Date: October 25, 2017

Subject: Discontinuation of AL-KO Axis 3.5K 10" x 1-3/4" Electric Brake and Drum

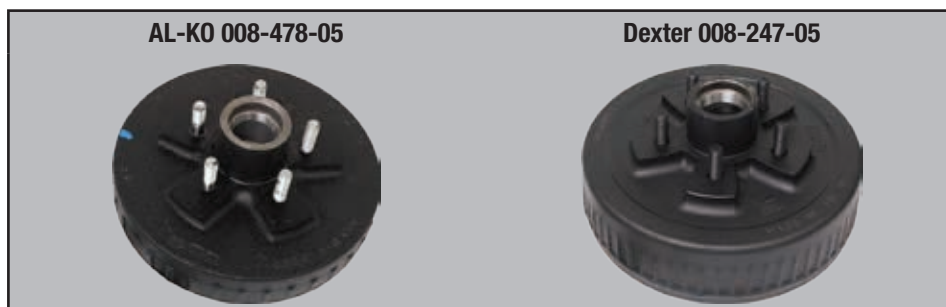
Existing AL-KO Axis 3.5K sprung or torsion axles in the field can be serviced by replacing the 10" X 1-3/4" electric brakes with Dexter's 10" x 2-1/4" 3.5K electric brakes and drums. The spindle and brake flange design allows for the interchangeability of the wider 2-1/4" Dexter brake & drum to be used in place of the 1-3/4" AL-KO brake & drum. Dexter recommends replacing the brake and drum in pairs, and not individually.
